REFERRAL REPORT

TO: Vancouver City Council
FROM: General Manager of Planning, Urban Design and Sustainability
SUBJECT: CD-1 Rezoning: 103-111 North Templeton Drive and 2185 Oxford Street

103-111 North Templeton Drive and 2185 Oxford Street
FORM OF DEVELOPMENT DRAWINGS

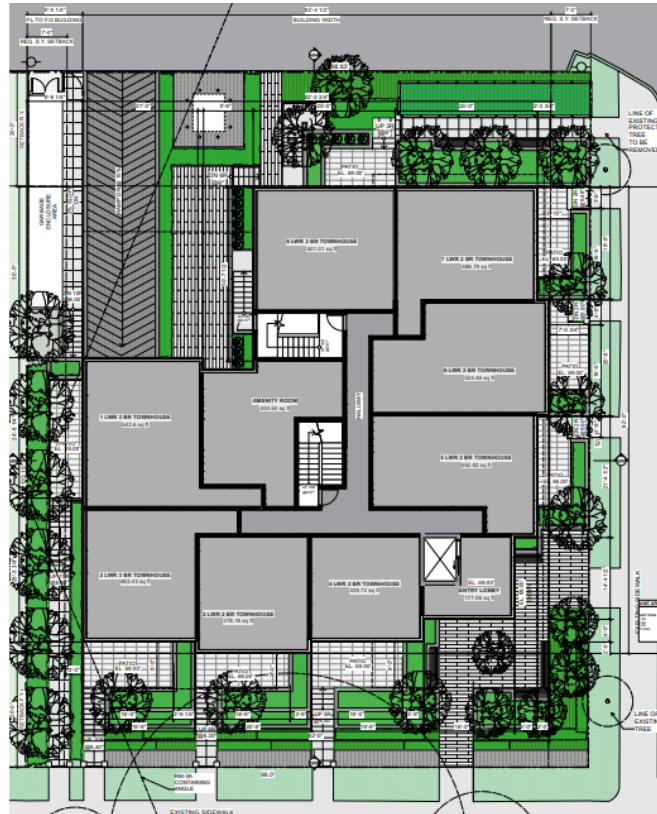
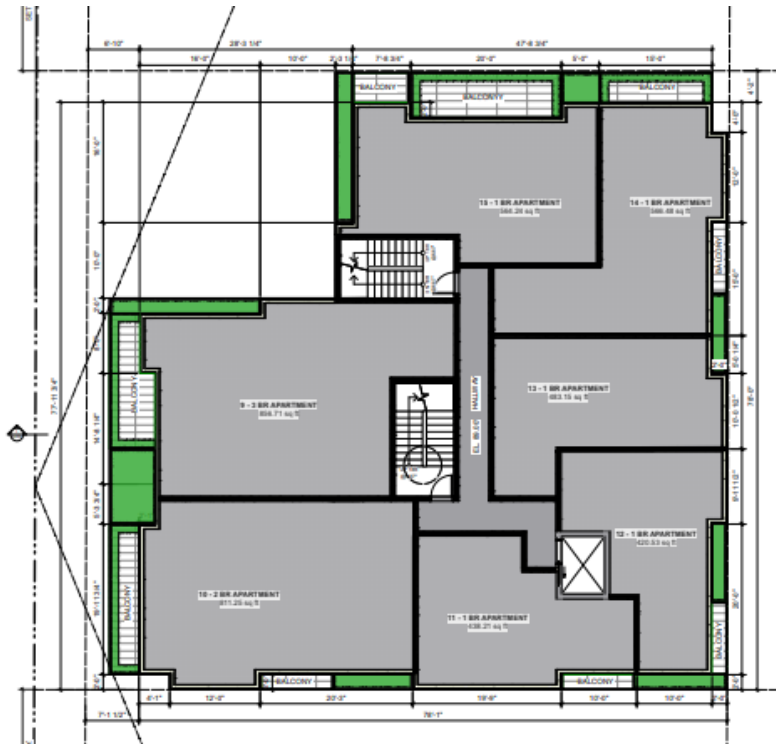
Note to Applicant: Delete all proposed structures that appears to encroach over the North and East property lines on to City Property (Sheets A3.02, A3.03, and A3.04).
- 2.2 Provision of a Services Agreement to detail the on-site and off-site works and services necessary or incidental to the servicing of the site (collectively called the "Services")
